Final comments: CN

From: Umair Naveed <Umair.Naveed@cn.ca>
Sent: Monday, April 17, 2023 1:59 PM
To: Andrew Martin <andrew.martin@Wilmot.ca>
Subject: RE: 1856 Snyder's road Petersburg ON

Grade Crossing Safety Compliance Assessment

Petersburg Sand Company Inc. (PSC)
Proposed Farm Crossing Relocation

DRAWING TITLE
PASSIVE RAILWAY CROSSING DETAILS

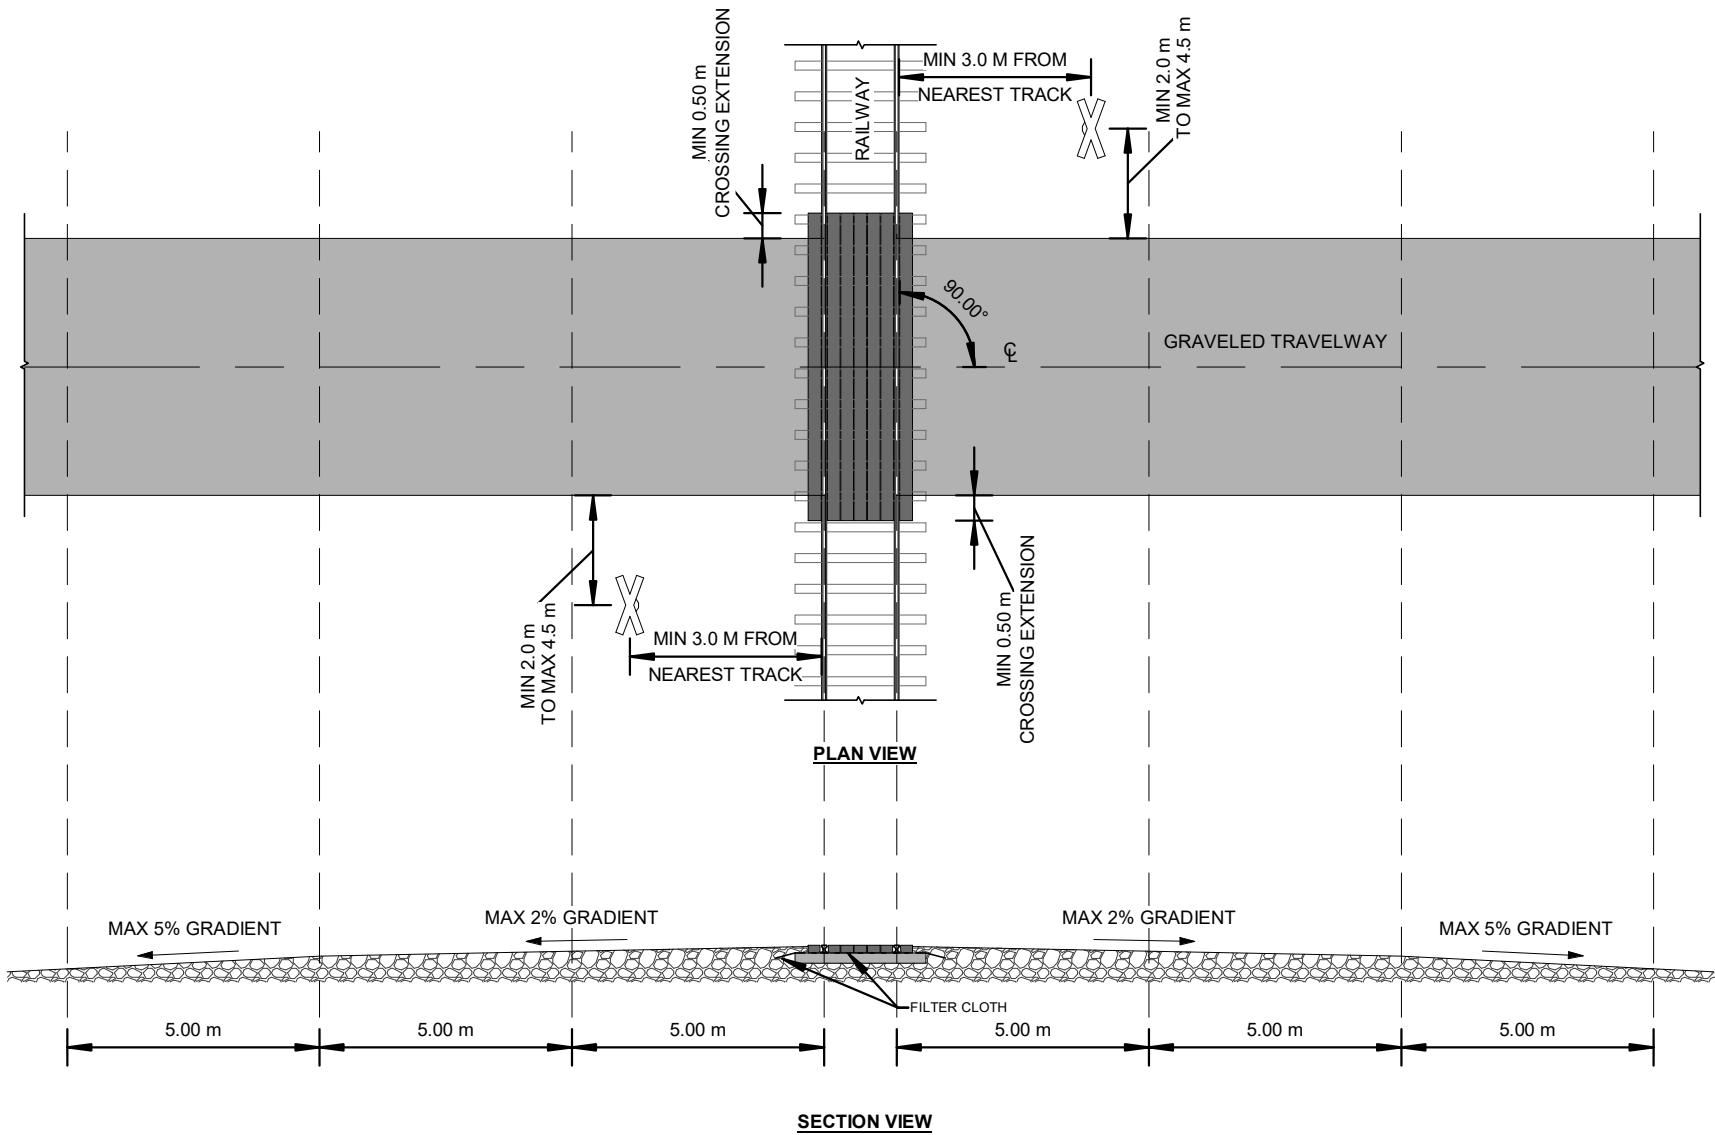
- Max 2 % approach grade for first 10m and 5 % after that is required at the approach to the crossing.
- Due to long vehicles the roadway approaches remain less than the maximum of 5 %.
- PSC will clear the vegetation and level off the ground to provide sightline of 652m from the stop position.
- CN will verify the available sightline of 652m in all four quadrants or consider installing a warning system at owner's cost.
- PSC will install an access gate that prohibits the use of crossing when sand pit operations are not running.
- PSC will consider installing asphalt crossing approaches.
